**TOWN OF FAIRFAX  
STAFF REPORT  
Department of Planning and Building Services**

**TO:** Fairfax Planning Commission  
**DATE:** July 15, 2021  
**FROM:** Ben Berto, Director of Planning and Building  
**LOCATION:** 403 Cascade Drive; Assessor's Parcel No. 003-044-10  
**ZONING:** Residential Single-family RS-6 Zone  
**PROJECT:** Construction of a new single-family residence  
**ACTION:** Use Permit and Design Review Permit; Application # 21-10  
**APPLICANTS/** Jon Fernandez/Fernandez S2 Partnership Architecture  
**OWNERS:** Daniel Thompson  
**CEQA STATUS:** Categorically exempt, §15303

## 403 CASCADE DRIVE

Figure 3

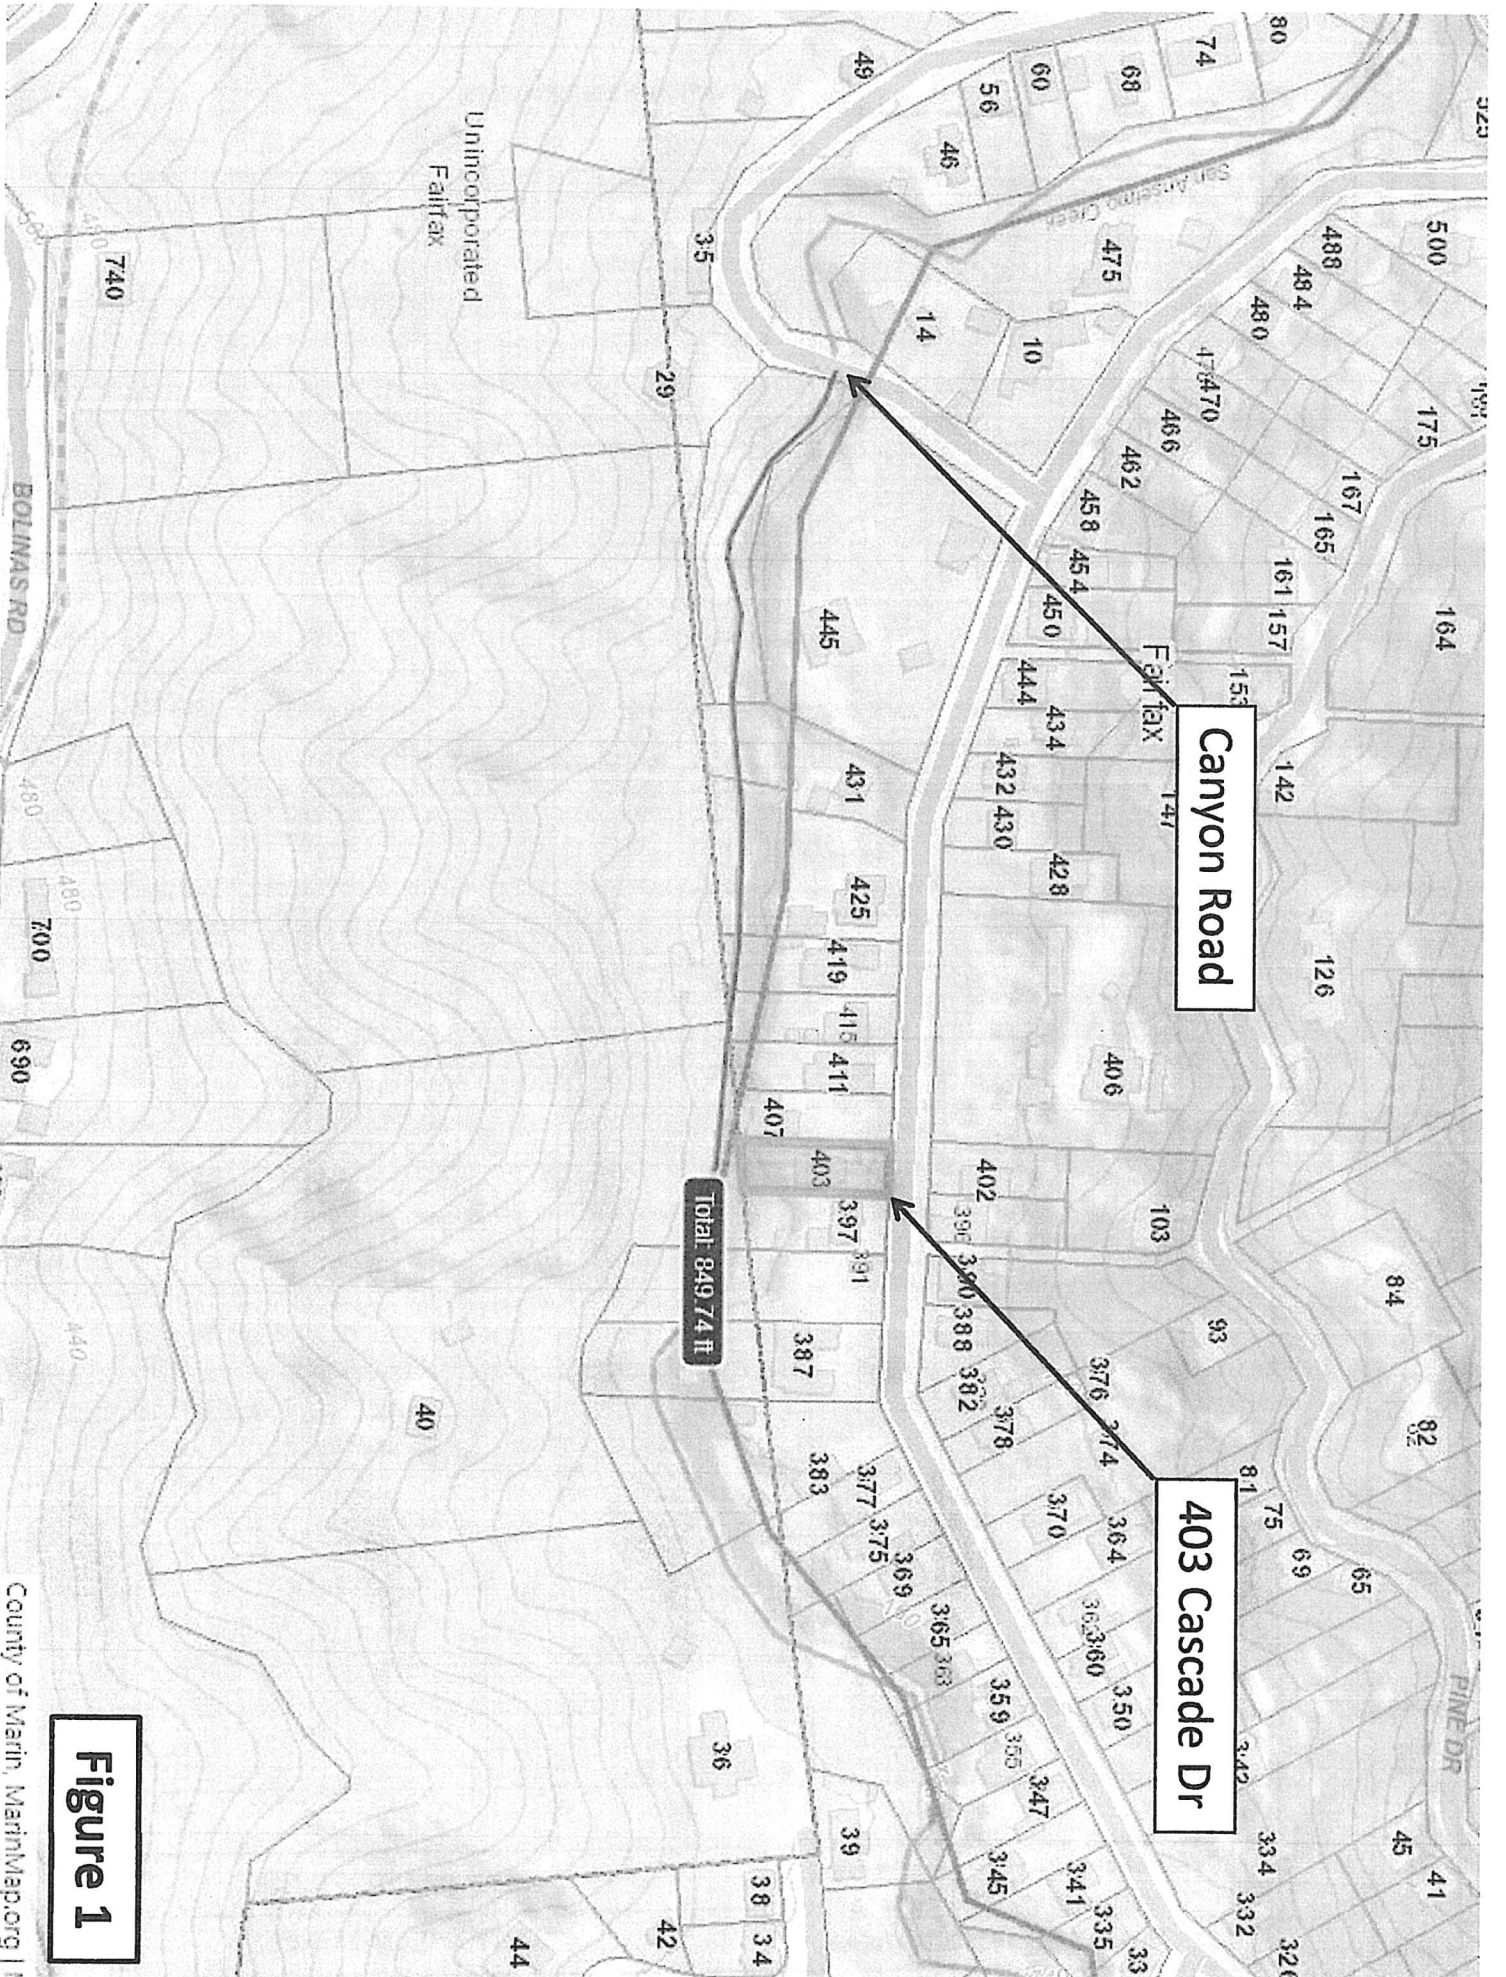
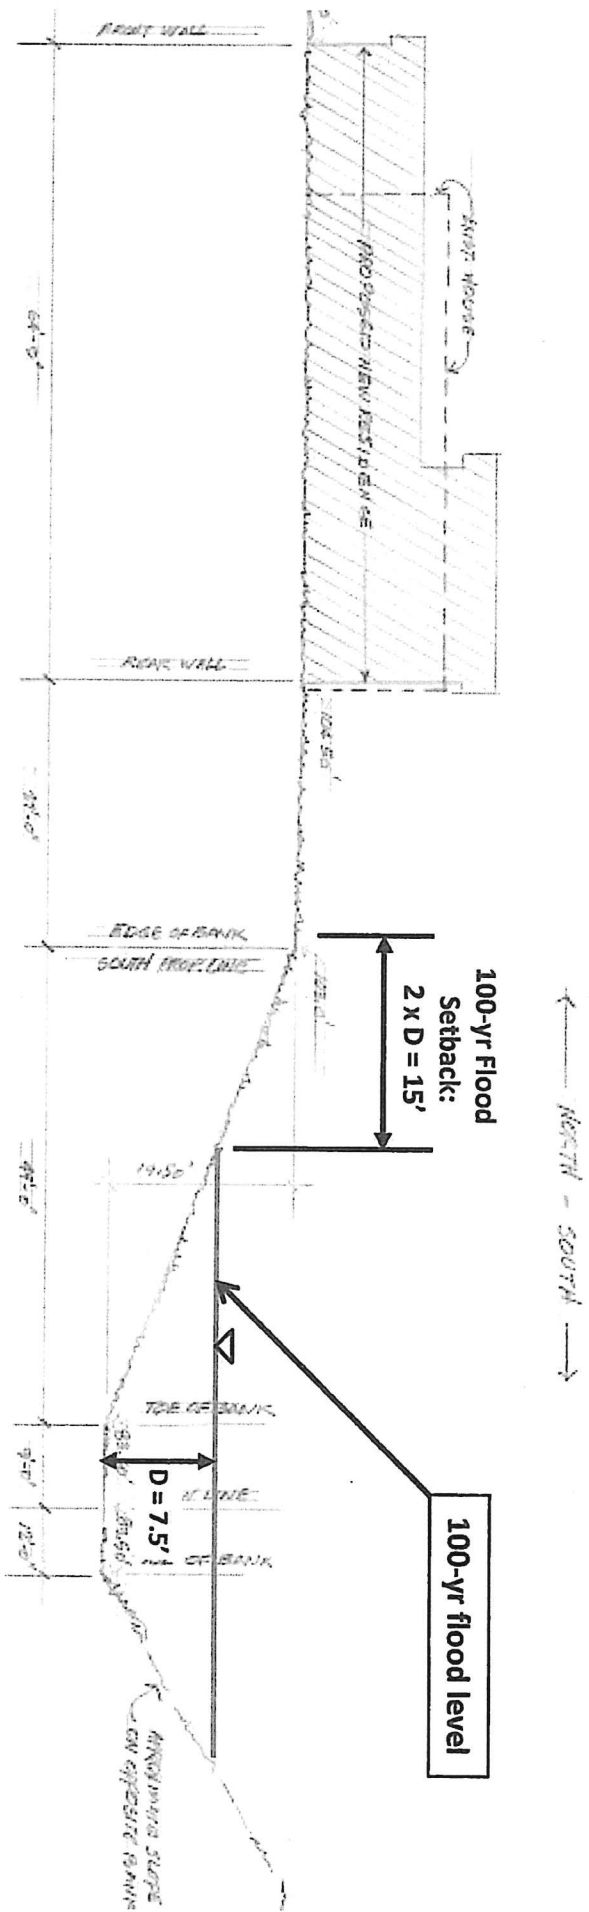
The Questa study reports the 100-year flood depth at 7.5 feet, which places the two-times-depth-of-bank distance well outside the building footprint, as does the 20-foot distance from top of bank (see Attachment C diagram).

3. **Figure 3.** Using the 7.5-ft depth of 100-yr flooding, the flood surface was drawn on a cross-section of the project site (provided by JSF Architecture) to determine the point of intersection of the 100-yr water surface elevation on the creek channel bank adjacent to 403 Cascade Dr. The prescribed 100-yr flood setback, taken from the edge of the 100-yr flood zone, is shown as twice the depth of flooding or  $(2) \times (7.5') = 15'$ .

ROOF DRAINAGE PLAN 1/4" = 1'-0"  
 SHIP LIFTING: TRUSS AND BUILDS

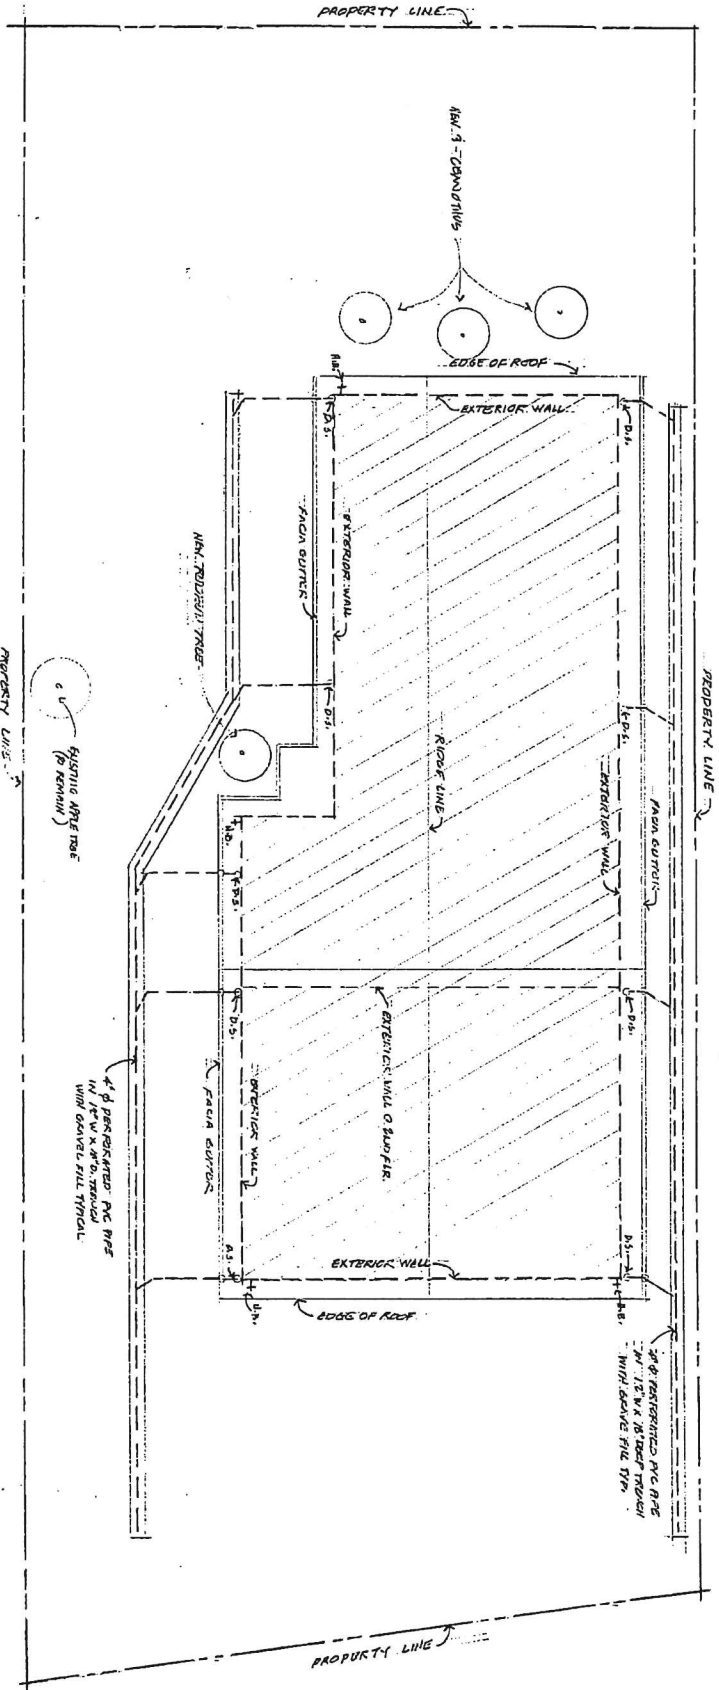
A landscaping and drainage plan has also been provided, showing Ceanothus plants in front of the garage and providing adequate street screening (see Attachment D).
